■ SEAT LAYOUT

04Z8BO31

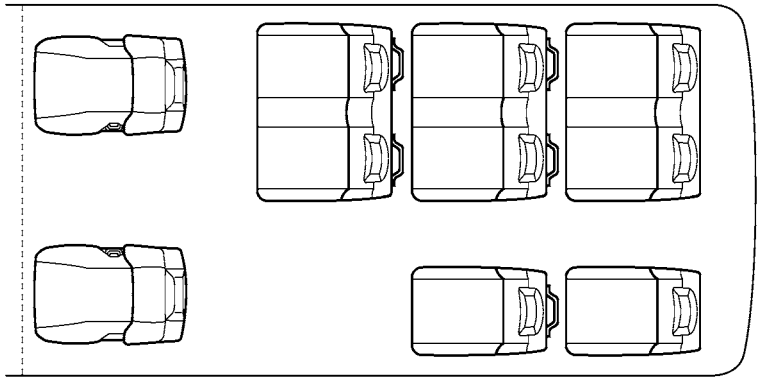
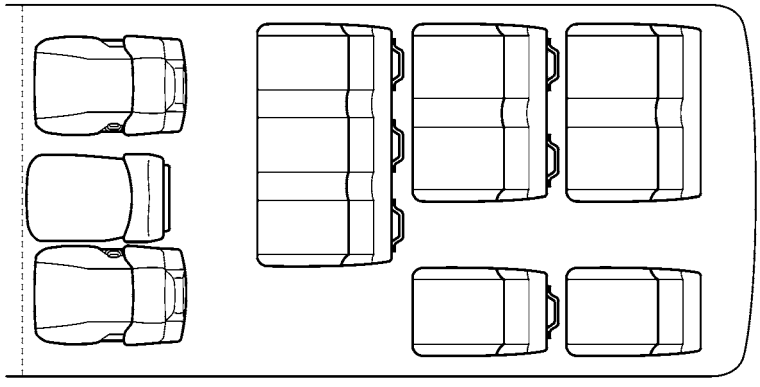
- The number of passengers and the seat layout of the commuters of Malaysia have been changed from 12 (3 + 3 + 3 + 3) to 10 (2 + 2 + 3 + 3).

04Z8BO32

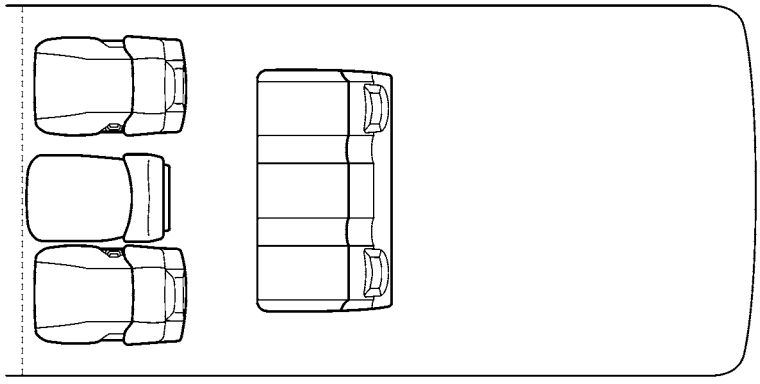
- For vans with wide body and super long wheel base adopted newly for South Africa, a 3-passenger rear seat has been added, making the number of passengers to 6 in total (3 + 3). In addition, the 3-passenger rear seat has been equipped with a reclining structure, a folding function and head rests on both sides.
- The 3-passenger model (a separated type 3-passenger front seat (1 + 1 + 1)) for South Africa has been abolished.

04Z8BO34

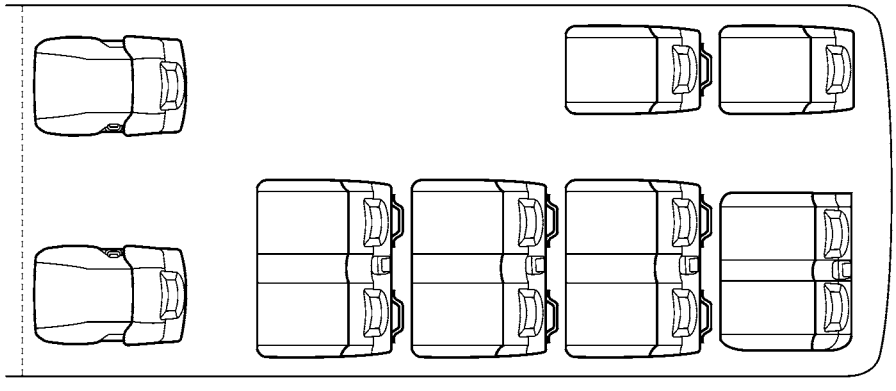
- A 12-passenger model (2 + 2 + 2 + 3 + 3) has been adopted for the Morocco package commuters.

04Z8BO36

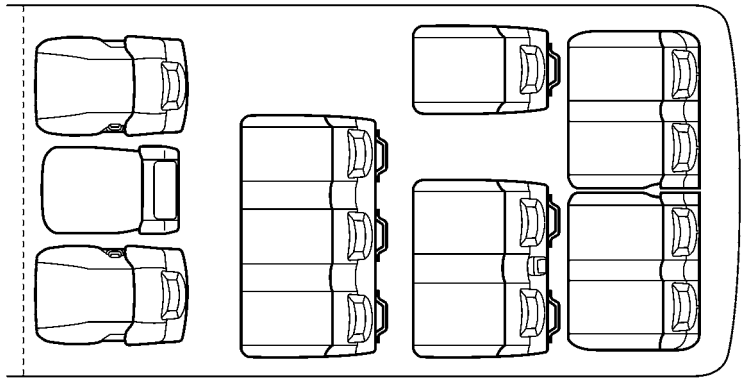
- The number of passengers and the seat layout of the 4-door, wide body Philippines package models has been changed from 11 (2 + 3 + 3 + 3) to 13 (3 + 3 + 3 + 4).

04Z8BO37

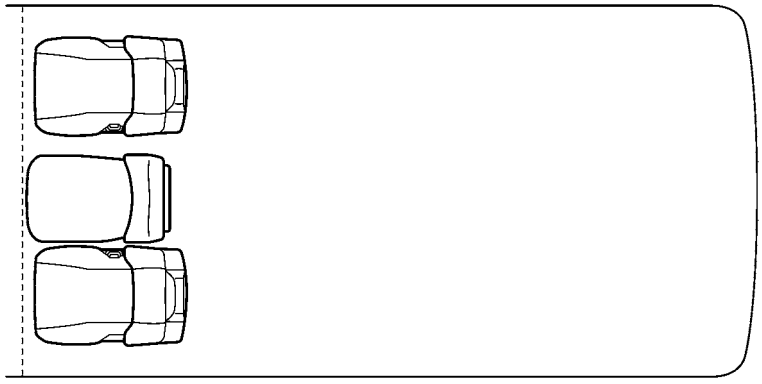
- The front seat of the vans for Australia has been changed from the 3-passenger seat (bench type (1 + 2) or separated type (1 + 1 + 1)) to a 2-passenger seat (1 + 1).
